NATIONAL FIRE PROTECTION ASSOCIATION

M E M O R A N D U M

SUBJECT: NFPA 13D Second Draft Technical Committee FINAL Ballot Results (A2024)

Figure 8.1.1.4(a) Sidewall Sprinklers Positioned to Discharge Downward Along the Slope.

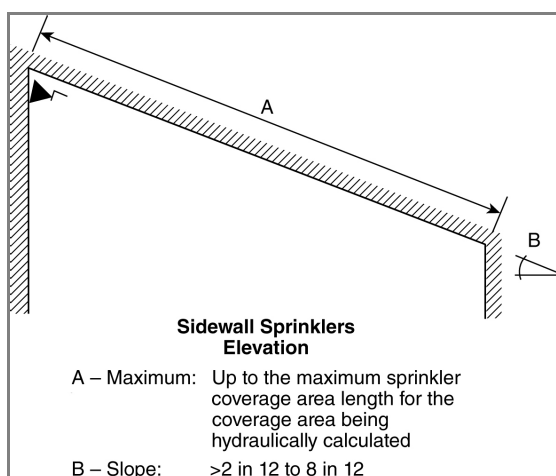
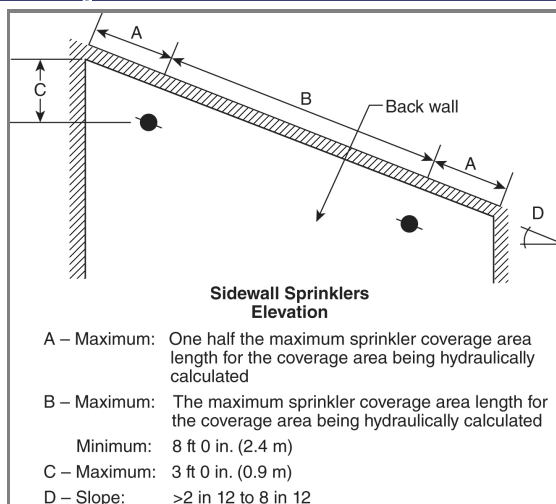
Committee Statement: This adds a figure to help illustrate the new concept for positioning sidewall sprinklers under sloped ceilings found in Section 8.1.1.4. The decision was made to put the figures in the body of the standard instead of the annex. Public Comment 16 was chosen to correlate with action taken in NFPA 13 for Second Draft.

- (1) At the high point of the slope and positioned to discharge downward along the slope as shown in Figure 8.1.1.4(a).
- (2) Along slopes not exceeding 8 in 12 with the deflector installed parallel to the slope and positioned to discharge across the slope as shown in Figure 8.1.1.4(b).

Figure 8.2.5.3.2 Positioning of Sprinkler to Avoid Obstruction to Discharge (Residential Upright and Pendent Spray Sprinklers).

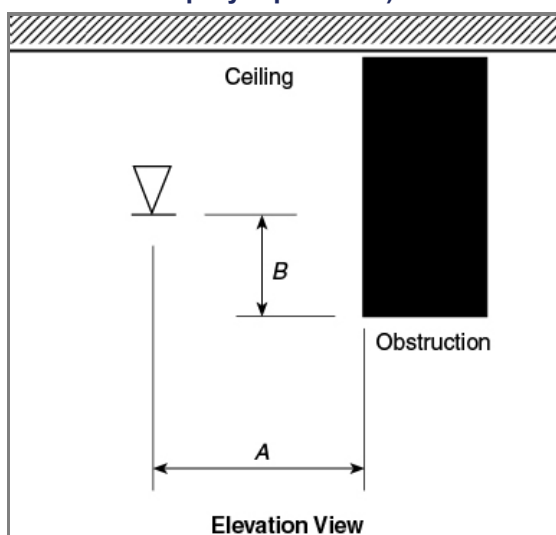
It is suggested that "spray" be removed from the figure titles for 8.2.5.3.2, 8.2.5.3.3(a), 8.2.5.3.3(b), 8.2.5.3.3(c), and 8.2.5.4.2(d) in NFPA 13 as "spray" has been removed from "spray sprinkler" in several FR changes. This maintains consistency throughout the standard.

Sprinklers shall be positioned with respect to continuous obstructions in accordance with Table 8.2.5.3.2 and Figure 8.2.5.3.2.

Figure 8.2.5.4.2(a) Positioning of Sprinkler to Avoid Obstruction (Residential Sidewall Sprinklers).

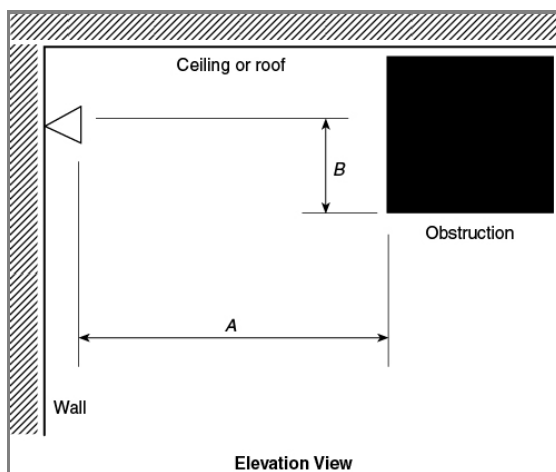
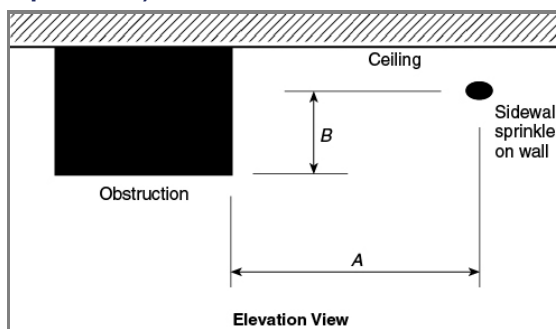
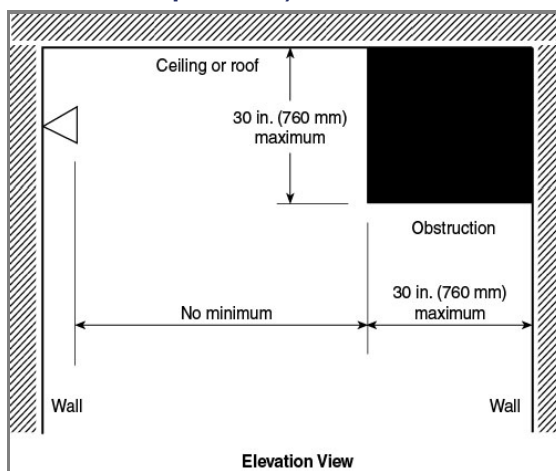
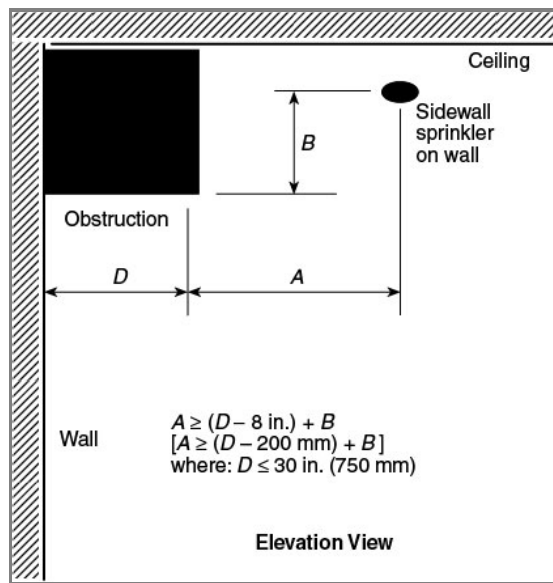
It is suggested that "spray" be removed from the figure titles for 8.2.5.3.2, 8.2.5.3.3(a), 8.2.5.3.3(b), 8.2.5.3.3(c), and 8.2.5.4.2(d) in NFPA 13 as "spray" has been removed from "spray sprinkler" in several FR changes. This maintains consistency throughout the standard.

Sprinklers shall be positioned with respect to continuous obstructions in accordance with Table 8.2.5.4.2(a), Figure 8.2.5.4.2(a), Table 8.2.5.4.2(b), Figure 8.2.5.4.2(b), Figure 8.2.5.4.2(c), and Figure 8.2.5.4.2(d).

Figure 9.2.3.2.1 Arrangement of Supply Piping with Backflow Device.

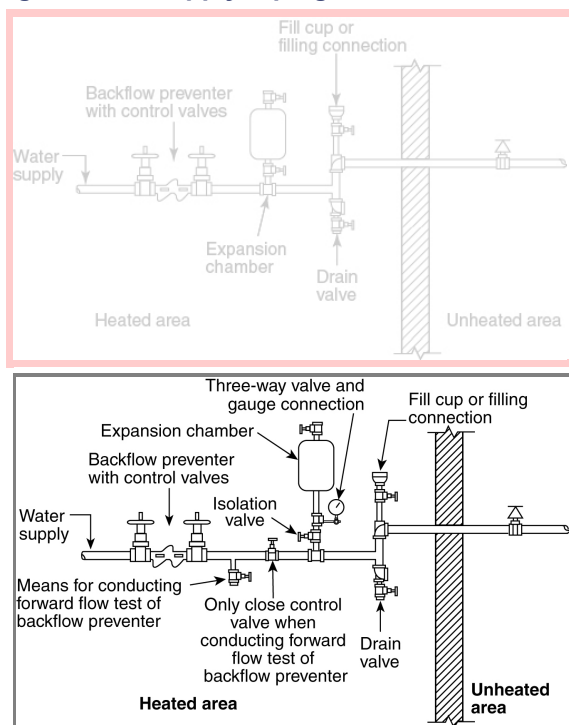
As part of FR-1258, Figure 8.6.3.3 of NFPA 13 was updated to include a three-way valve and gauge connection. It is recommended that Figure 9.2.3.2.1 of NFPA 13D be revised to include the three-way valve and gauge connection to maintain consistency between the standards.

The substantiation indicates that a 3-way valve and gauge was added to the figure as recommended by the TCC. However, the new figure also includes additional valves for full forward flow testing of the backflow preventer. I am not aware of a requirement in NFPA 13D that requires a full flow test of the backflow preventer. I would also consider this new material. I recommend voting negative and addressing this in the next cycle.

Committee Statement: Figure 9.2.3.2.1 was revised to include a three-way valve and gauge connection.
